Memo

Application Number: 200328

Address: Vastern Court Caversham Road Reading

Transport Comments

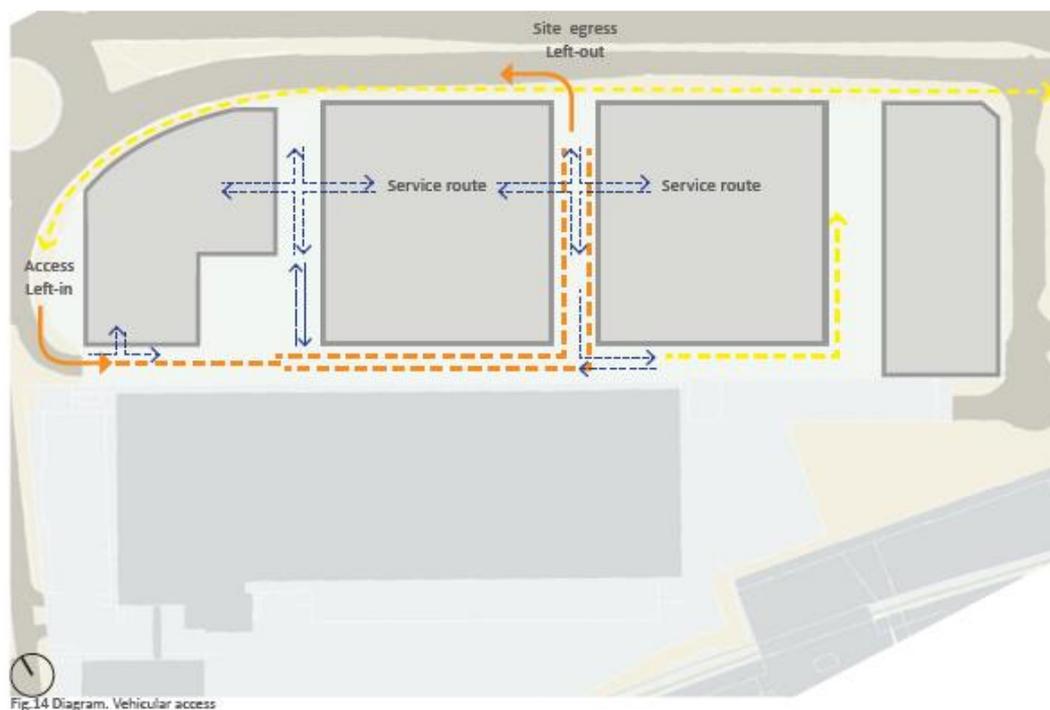
However, the outline application seeks to agree servicing and therefore this would need to be fully assessed now and not at the reserved matters stage. As such the Delivery and Servicing Management Plan (DSMP) with appropriate tracking must be submitted alongside this application for determination.

- The proposal includes servicing routes that go under the buildings themselves as a shared access to the undercroft parking courts. It should be noted that to facilitate access to these undercroft areas a minimum head height of 5m would be required.

- Dedicated loading bays should be provided to ensure that vehicle access routes are not obstructed.
- Plot C would require on site turning so that service vehicles are not reversing out on to the north south vehicular exit route.

- It is noted that Plot D is to be served from Trooper Potts Way and requires the provision of a new loading bay which would result in the removal of the existing footway on the Public Highway, which is contrary to the Transport Statement which states that all servicing would be from within the site. In addition, no plans have been provided that identify a relocated footway between Plot D and the loading bay, this would need to be provided and included as a footway to be adopted. Revised plans must therefore be submitted clearly defining the re-provided footway and confirm the extent of a 2m wide footway for adoption.

- It would also need to be ascertained how access to the loading bay would be gained given that no through route is proposed and no turning facility is provided on Trooper Potts Way itself. The adopted Highway only extends 51m approx. along Trooper Potts Way and therefore access over third party land would need to be sought. It is noted that the DAS identifies Bagnell Way as a bus only route except for station access.

- It is proposed to serve Plot A via an access located in the north east corner of the building which will result in vehicles having to reverse along the pedestrianized route leading to the existing signalized crossing on Vastern Road. This would be detrimental to Highway safety and cannot be supported. The proposal must therefore provide separate vehicle and pedestrianized areas not only adjacent to

the loading area but along this north south route. This may be a secondary route but it will still play an important role in providing pedestrian and cycle access to the north.

- I note the fire strategy identified at 6.11 of the DAS which identifies the extension of the central street to the east so that it runs along the southern boundary of Plot C and connects to a temporary access onto Trooper Potts Way. However, this should be clarified in more detail. In addition to this point I note paragraph 3.4 of the Design Code and in particular Figure 14, included below. These identify the provision of a controlled two-way service route along the southern boundary of Block C, this again would need more clarification and detail as to how this would be controlled, who would have access and how vehicles would turn so that vehicles are not reversing along a pedestrianized route.

The servicing strategy should therefore be revised to reflect the above.
